RE: Breeze @ South Peak, W.O. # 641481, (J-22/D066)
Engineers Certification for Release of Financial Guaranty
Engineers Stamp dated 04/21/2000
Engineers Certification dated 06-03-11

DRAINAGE REPORT
FOR
Breeze at South Peak Town Homes
(EASTRIDGE AND INDIAN SCHOOL)

**Re: Revised Drainage Plan for the Breeze at South Peak
Engineer's stamp 4-12-00 (J22/D66)**

Re: Breeze at South Peak Drainage Report
Engineer's Stamp dated 3-13-00 (J22/D66)

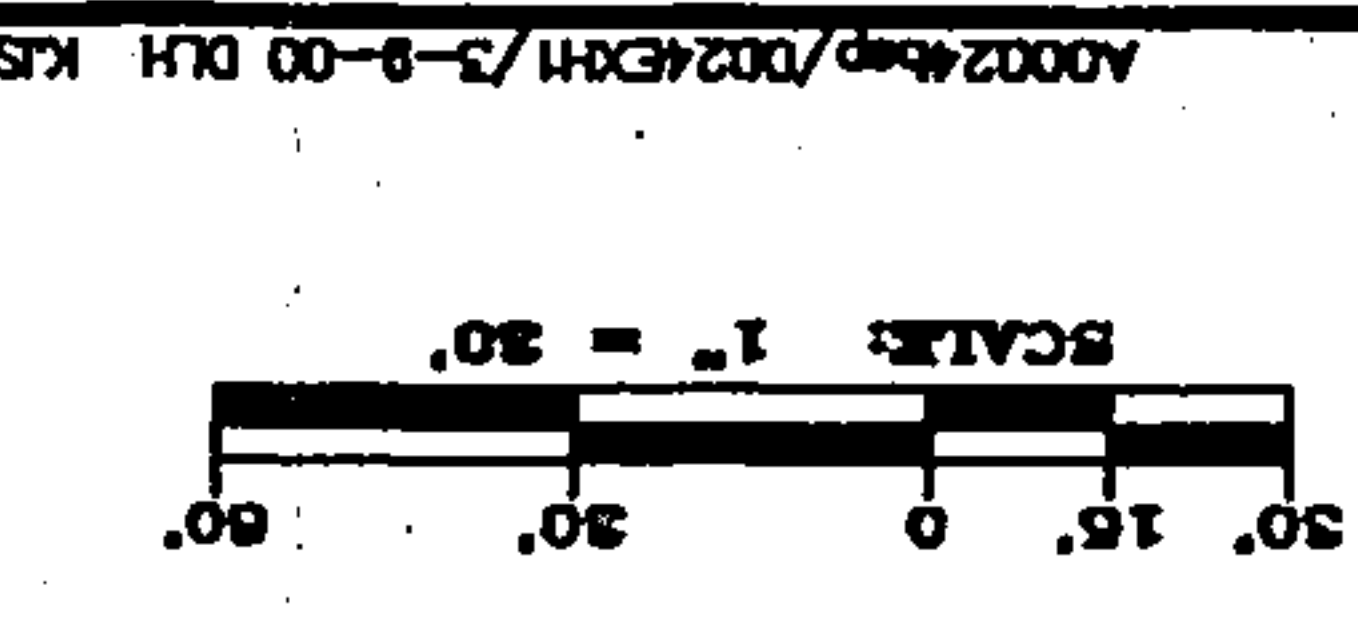
- Please add sub basin 4 (which includes Lots 1 and 27) to your summary table.
- Please add some additional spot elevations in the area across the street from lots 33 thru 28 to make sure that this area drains back to the street.
- Please add a handicap ramp to western entrance.

7. Subbasin 4 has been added to Exhibit 2.
8. Additional spot elevations along the western property line have been added.
9. Handicap ramp has been added to the western entrance road.
